**Corstorphine Connections – Phase 2**  
Stage 1 and 2 Road Safety Audit  
City of Edinburgh Council

September 2023

Client	City of Edinburgh Council
RSA team organisation	Atkins
Report title	Corstorphine Connections – Phase 2 Stage 1 and 2 Road Safety Audit
Client Reference	-
Atkins reference	8003-676

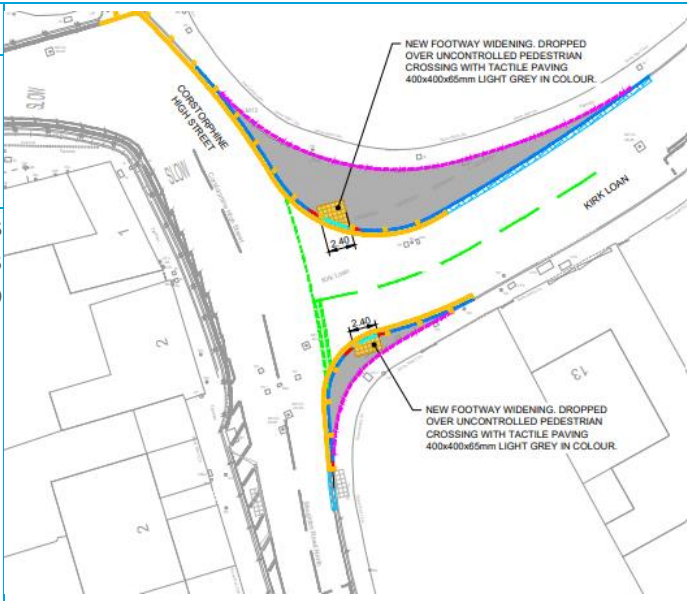
<b>Problem:</b>	3.1
<b>Location(s):</b>	Scheme extents
<b>Drawing(s):</b>	60636731-SHT-C-P2-LTN-0701 to 60636731-SHT-C-P2-LTN-0706
<b>Summary:</b>	Worn road markings may give rise to unplanned driver behaviours.

Whilst it is appreciated some road markings are to be installed/refreshed as part of the scheme, it was observed on site that several road markings are worn, including:

The worn markings increase the likelihood of drivers failing to give way, not moderating speed, obstructing junctions and other users by stopping/parking at adverse locations. These behaviours increase the likelihood of vehicle conflicts and collisions.

It is recommended that worn road markings are refreshed across the scheme extents.

3.1	Worn road markings may give rise to unplanned driver behaviours.	It is recommended that worn road markings are refreshed across the scheme extents.	Problem noted and accepted. Design proposals show locations where existing road markings are affected by our works and will be renewed. Any wider road markings not directly affected by the scheme are not within the scope / budget of the project.	As per design organisation's response	Noted for consideration under future schemes

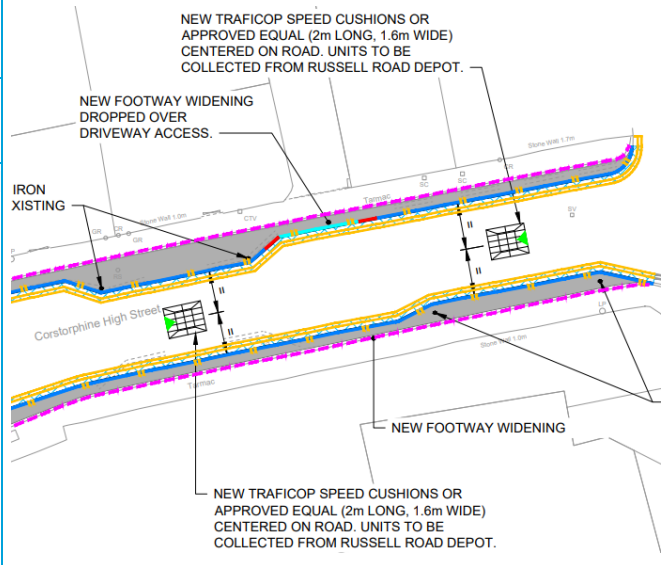
<b>Problem:</b>	<b>3.2</b>
<b>Location(s):</b>	Scheme extents
<b>Drawing(s):</b>	60636731-SHT-C-P2-LTN-0701 to 60636731-SHT-C-P2-LTN-0706
<b>Summary:</b>	Risk of collisions resulting from vehicles being unable to simultaneously manoeuvre.

The existing carriageway geometry is to be amended at several junctions where footway widening, and buildouts are proposed. The reduced junction and carriageway widths may be unable to accommodate all vehicle manoeuvres without encroaching adjacent running lanes and footways. This increases the likelihood of side impact or head-on collisions.

It is recommended that all anticipated vehicle manoeuvres can be safely accommodated.

3.2	Risk of collisions resulting from vehicles being unable to simultaneously manoeuvre.	It is recommended that all anticipated vehicle manoeuvres can be safely accommodated.	All junction modifications have had swept path analysis undertaken to determine radius / widths.	As per design organisation's response	No action

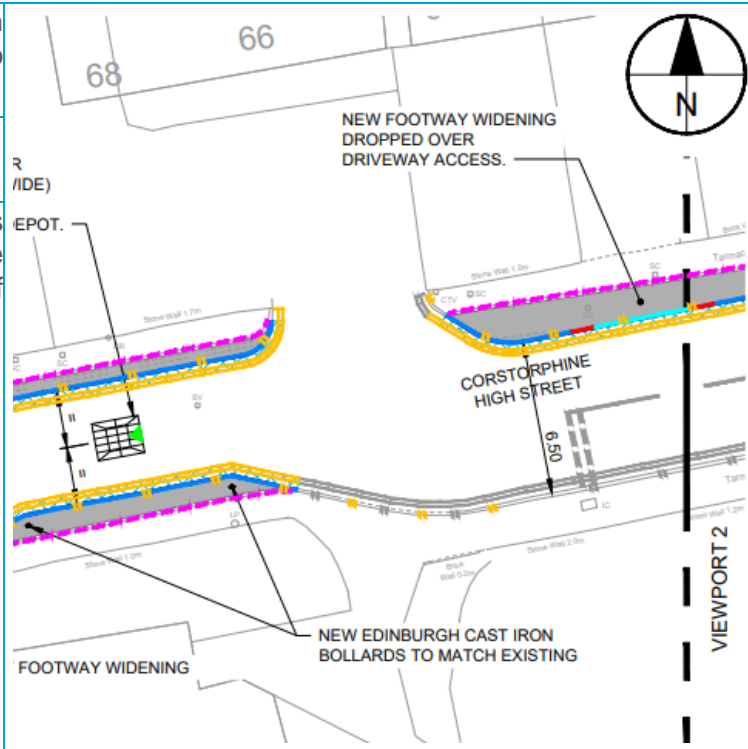
<b>Problem:</b>	<b>3.3</b>
<b>Location(s):</b>	Corstorphine High Street, priority one-way working
<b>Drawing(s):</b>	60636731-SHT-C-P2-LTN-0701
<b>Summary:</b>	Inconspicuous speed cushions could result in road user injury.

Two speed cushions are proposed on Corstorphine High Street at the priority one-way working between Ladywell Avenue and Corstorphine Primary School. The proposals indicate the provision of only one triangle marking on each speed cushion. The absence of triangle markings/dragon teeth in both directions could reduce driver visibility of the traffic calming features, particularly during the hours of darkness. This presents a risk to road users, especially those on two wheeled vehicles, who may be unsteadied and fall.

It is recommended that dragon teeth are installed on both approaches to the speed cushions.

3.3	Inconspicuous speed cushions could result in road user injury.	It is recommended that dragon teeth are installed on both approaches to the speed cushions.	Problem noted and accepted - dragon teeth to be added on all approaches to speed cushions	As per design organisation's response	Dragon teeth to be added on all approaches to speed cushions

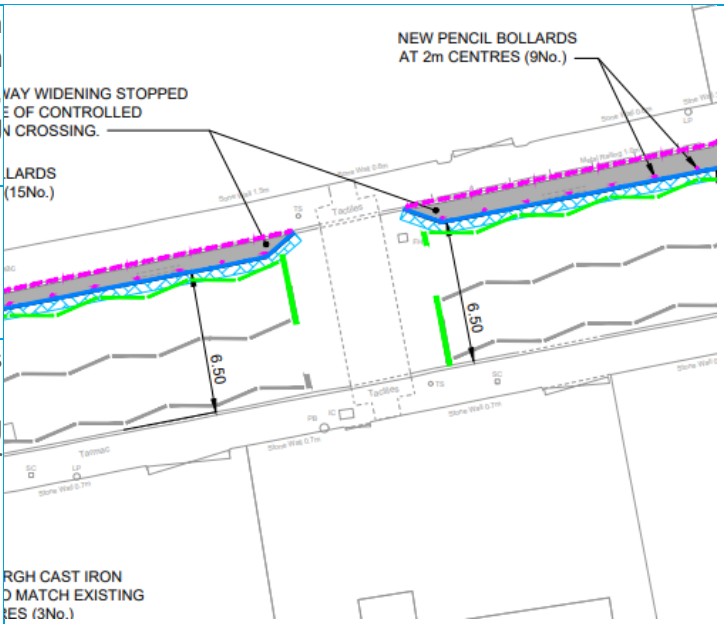
<b>Problem:</b>	<b>3.6</b>
<b>Location(s):</b>	Corstorphine High Street, priority one-way working
<b>Drawing(s):</b>	60636731-SHT-C-P2-LTN-0701
<b>Summary:</b>	Risk of driver confusion and drivers failing to give way resulting in collisions.

The existing give way sign associated with the priority one-way working between Ladywell Avenue and Corstorphine Primary School is located west of the give way road markings. During the site visit, a vehicle was observed giving way to eastbound traffic at the signage location and not at the road markings where the carriageway is wider to accommodate two-way traffic flows. The distance between the road markings and signage may confuse drivers as to the intended operation of the priority system and increases the risk of collisions should vehicles fail to give way at the location intended.

It is recommended that the give way signage is relocated closer to the give way markings.

3.6	Risk of driver confusion and drivers failing to give way resulting in collisions.	It is recommended that the give way signage is relocated closer to the give way markings.	Problem noted and accepted - give way signage to be installed closer to markings	As per design organisation's response	Give way signage to be installed closer to markings

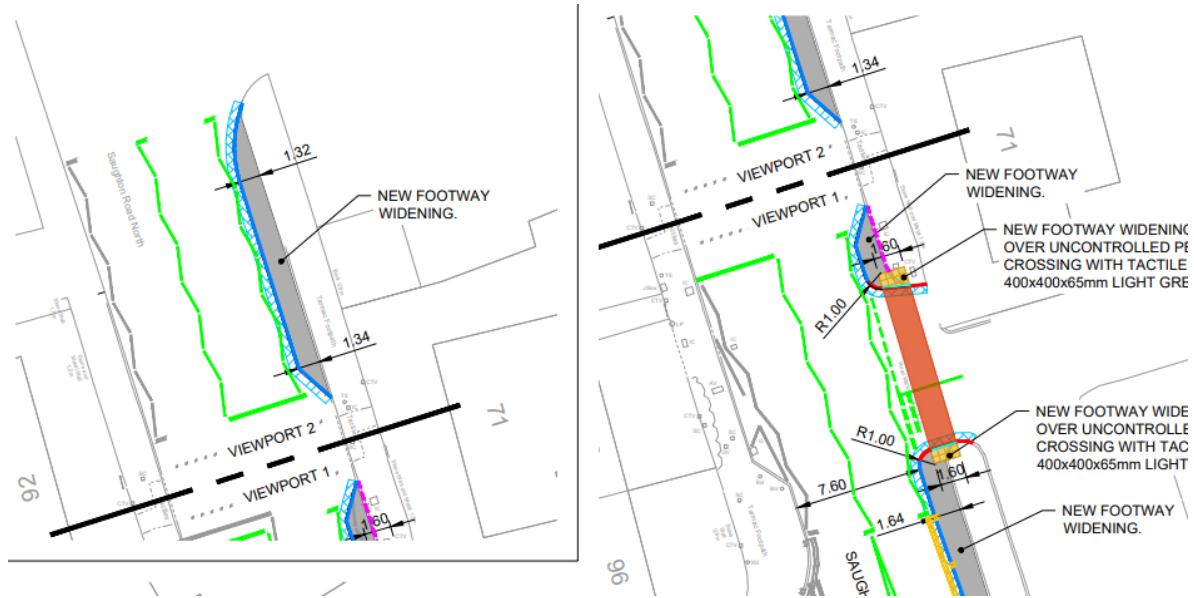
<b>Problem:</b>	<b>3.7</b>
<b>Location(s):</b>	Corstorphine High Street and Saughton Road North, signalised crossing facilities
<b>Drawing(s):</b>	60636731-SHT-C-P2-LTN-0701 and 60636731-SHT-C-P2-LTN-0703
<b>Summary:</b>	Risk of pedestrians accessing/egressing from the crossing facilities tripping over kerbs.

Footway widening is proposed on the north footway at Corstorphine High Street and east footway at Saughton Road North. The proposals indicate that the widened footways will taper into the existing kerb lines at the signalised crossing facilities. The tapered kerbs pose a trip hazard to pedestrians transitioning to/from the crossing facilities and to those travelling along the widened areas of footway.

This risk is exacerbated as the traffic signal poles are located within the middle of the existing footways. It is anticipated that pedestrians will choose to walk on the carriageway side of the signal poles to avoid the pinch point.

It is recommended that a consistent kerb alignment is provided.

3.7	Risk of pedestrians accessing/egressing from the crossing facilities tripping over kerbs.	It is recommended that a consistent kerb alignment is provided.	Bollards are proposed on the west side and guardrail has been proposed on the east side which will both help to delineate the path edge. A new signalised crossing was not within the scope or budget of the project.	As per design organisation's response	Bollards to be added

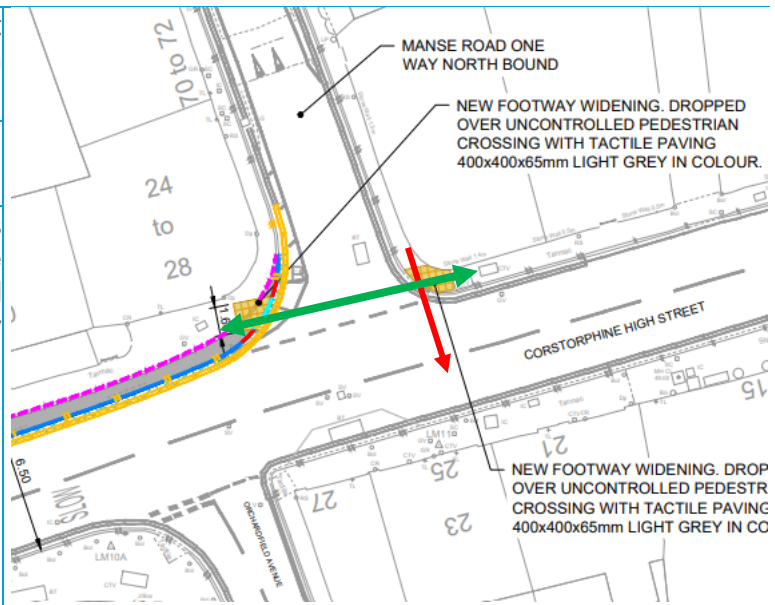
<b>Problem:</b>	<b>3.11</b>
<b>Location(s):</b>	Corstorphine High Street, westbound carriageway
<b>Drawing(s):</b>	60636731-SHT-C-P2-LTN-0701
<b>Summary:</b>	Defective carriageway surface could be unsteady for two-wheeled vehicles

The westbound carriageway surface at Corstorphine High Street looks comparatively newer than the eastbound carriageway, however several defects and cracks are present. The uneven surface presents a risk to cycles and motorcycles who may become unbalanced and suffer injury from falls. Additionally, broken and loose surface material increases the risk of vehicles skidding and secondary collisions occurring due to reduced tyre grip.

It is recommended that the carriageway is resurfaced.

3.11	Defective carriageway surface could unsteady two-wheeled vehicles	It is recommended that the carriageway is resurfaced.	Problem noted, however this is outwith the scope of the project and funding. Active Travel team to raise with relevant internal department for consideration.	As per design organisation's response	Active Travel team to raise with relevant internal department for consideration.

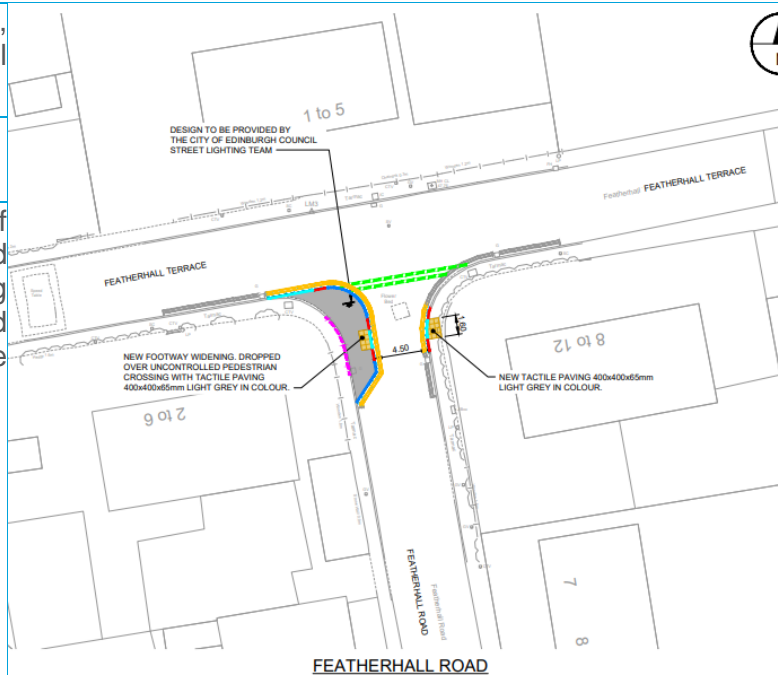
<b>Problem:</b>	<b>3.19</b>
<b>Location(s):</b>	Featherhall Road, at Featherhall Terrace
<b>Drawing(s):</b>	60636731-SHT-C-P2-LTN-0705
<b>Summary:</b>	Risk of vehicles colliding due to restricted visibility from the junction.

The buildout proposed at Featherhall Road, at its junction with Featherhall Terrace will locate northbound vehicles on the right side of the junction. As a result, driver intervisibility of vehicles approaching on Featherhall Terrace and of those exiting Featherhall Road is restricted by property lines and vegetation around the east side of the junction. This increases the risk of vehicles colliding whilst manoeuvring to and from the junction.

It is recommended that the proposed buildout is relocated to the east side of the junction to improve driver intervisibility.

3.19	Risk of vehicles colliding due to restricted visibility from the junction.	It is recommended that the proposed buildout is relocated to the east side of the junction to improve driver intervisibility.	The streets are within a quiet residential neighbourhood with low volumes and speeds. The locations of the buildouts were recommended in consultation with the Council's Road Safety team who manage the proposed school streets signs. The buildout is intentionally on the west side at this location to help aid enforcement.	As per design organisation's response	No action

Featherhall Road at Featherhall Terrace

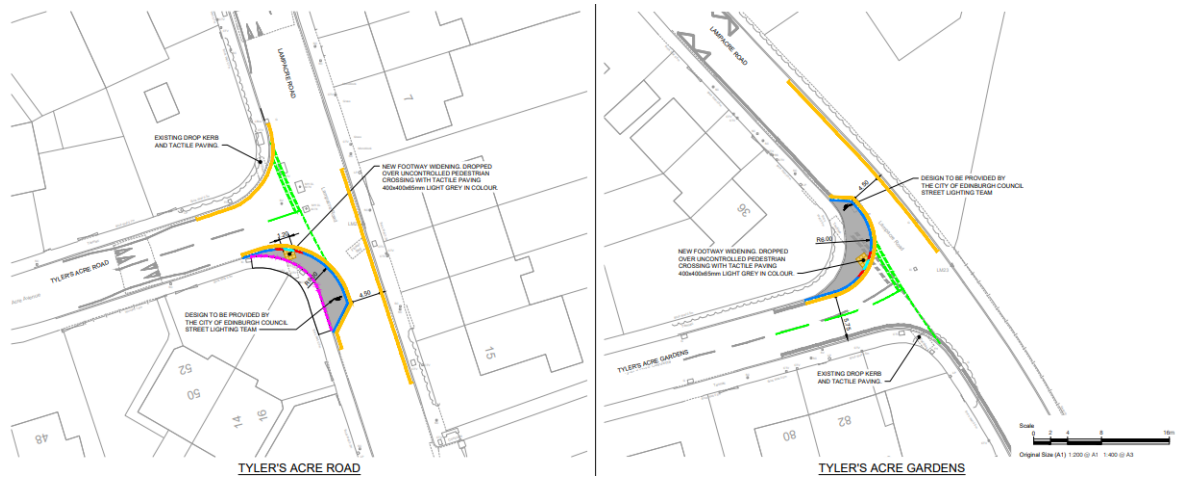
<b>Problem:</b>	3.21
<b>Location(s):</b>	Featherhall Road and Kirk Loan
<b>Drawing(s):</b>	60636731-SHT-C-P2-LTN-0703 and 60636731-SHT-C-P2-LTN-0705
<b>Summary:</b>	Risk of pedestrians tripping and falling in the carriageway.

The carriageway surfaces at the proposed uncontrolled pedestrian crossing facilities at Featherhall Road at Featherhall Terrace and Kirk Loan at Corstorphine High Street are uneven with several voids evident. These carriageway defects increase the likelihood of a crossing pedestrian tripping and suffering injury from falls.

It is recommended that the carriageway at the crossing locations are resurfaced.

3.21	Risk of pedestrians tripping and falling in the carriageway.	It is recommended that the carriageway at the crossing locations are resurfaced.	Problem noted, however this is outwith the scope of the project and funding. Active Travel team to raise with relevant internal department for consideration.	As per design organisation's response	Active Travel team to raise with relevant internal department for consideration.

**PROJECT NUMBER**  
60636731  
**SHEET TITLE**  
GENERAL ARRANGEMENT  
CORSTORPHINE HS/ KIRK LOAN  
SHEET 2 OF 6  
**SHEET NUMBER**  
60636731-SHT-C-P2-LTN-0702

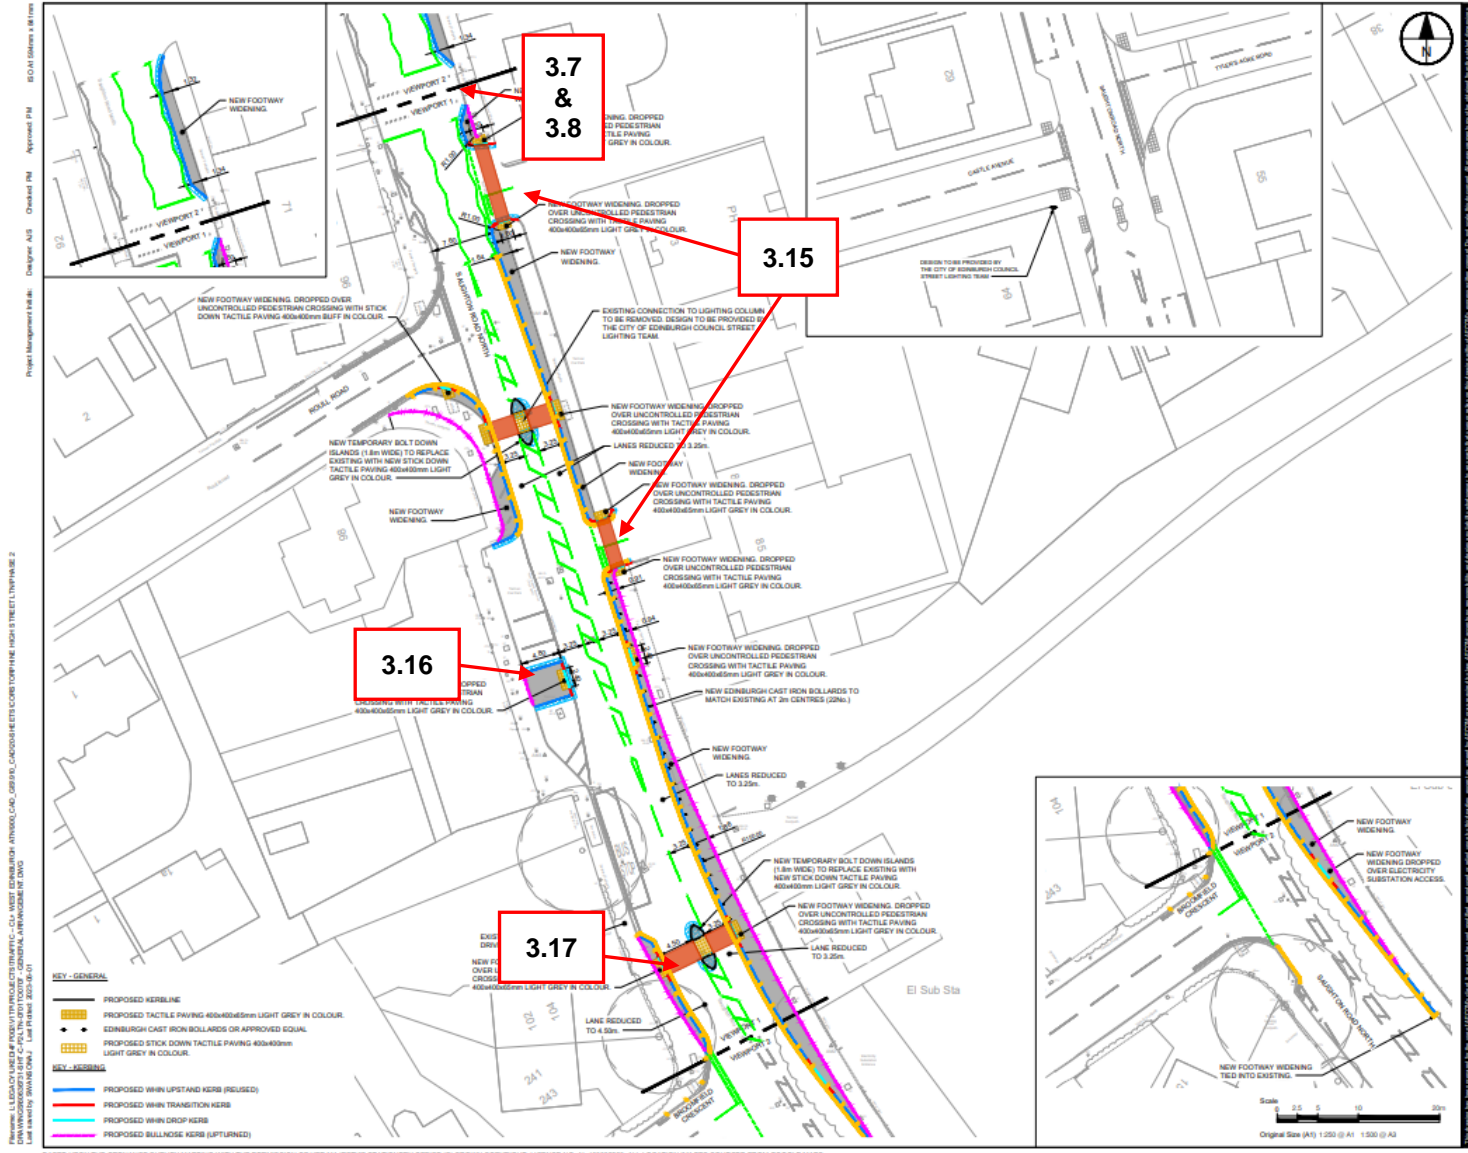
**Drawing(s):** 60636731-SHT-C-P2-LTN-0702

The tactile paving positioning relative to the radii of the junction could be interpreted in two ways. Pedestrians walking along Corstorphine High Street would be directed by the orientation of tactile paving across the side road correctly (indicated by the green arrow in the picture). However, those pedestrians walking along the Manse Road would also detect the tactile paving and crossing. In this case the tactiles would direct pedestrians across Corstorphine High Street, as indicated by the red arrow, where no connecting provision is provided. This increases the likelihood of pedestrian and vehicle collisions.

**Drawing(s):** 60636731-SHT-C-P2-LTN-0702

Footway buildouts are proposed at Kirk Loan at its junction with Corstorphine High Street. The current profile of the existing footways and carriageway where the buildouts are proposed look to form a channel, as illustrated above. There is therefore a risk that surface water may collect in these channels on the widened footways. This could form trip and slip hazards for pedestrians, particularly during periods of cold freezing weather.

<b>Problem:</b>	<b>3.14</b>
<b>Location(s):</b>	Northside of pedestrian crossing on Kirk Loan, at Corstorphine High Street
<b>Drawing(s):</b>	60636731-SHT-C-P2-LTN-0702
<b>Summary:</b>	Insufficient intervisibility at the crossing may result in pedestrian and vehicle collisions.

It was noted during the site visit that intervisibility between pedestrians and approaching vehicles at Kirk Loan is obstructed by parked vehicles. There is a risk of crossing pedestrians entering the carriageway into the path of an oncoming vehicle and being struck. This risk is exacerbated for smaller pedestrians who may be completely obstructed by a parked vehicle.

3.12	Risk of pedestrians entering the carriageway and being stuck by oncoming vehicles.	It is recommended that the tactile paving is realigned to better direct visually impaired pedestrians to the intended crossing facility.	The footway on the north/east of the High Street is particularly narrow and the tactile layout provides the best balance of what is achievable at this constrained location. The tactile paving on the east side is set from the High Street kerbline and as such, it is intended that those with visual impairments will recognise the orientation of the tactile paving and cross in the intended direction.	As per design organisation's response	No action

3.13	Risk of surface water collection at the proposed footway	It is recommended that sufficient drainage is provided.	Drainage has been provided as part of the scheme. This has been monitored on site, during high rainfall periods and it has been noted that ponding does not occur on these channels.	As per design organisation's response	Drainage under assessment

3.14	Insufficient intervisibility at the crossing may result in pedestrian and vehicle collisions.	It is recommended that sufficient visibility is provided at the crossing facility.	Visibility checked against 20mph SSD @ 25m. Confirm that southern crossing point is suitable, however, that the northern crossing point is sub-standard and a section of parking removal is recommended	Removal of this parking will be considered as part of a future permanent scheme. It is not within the powers of current ETRO trial to reduce waiting/loading provision at this location.	Noted for consideration under future schemes
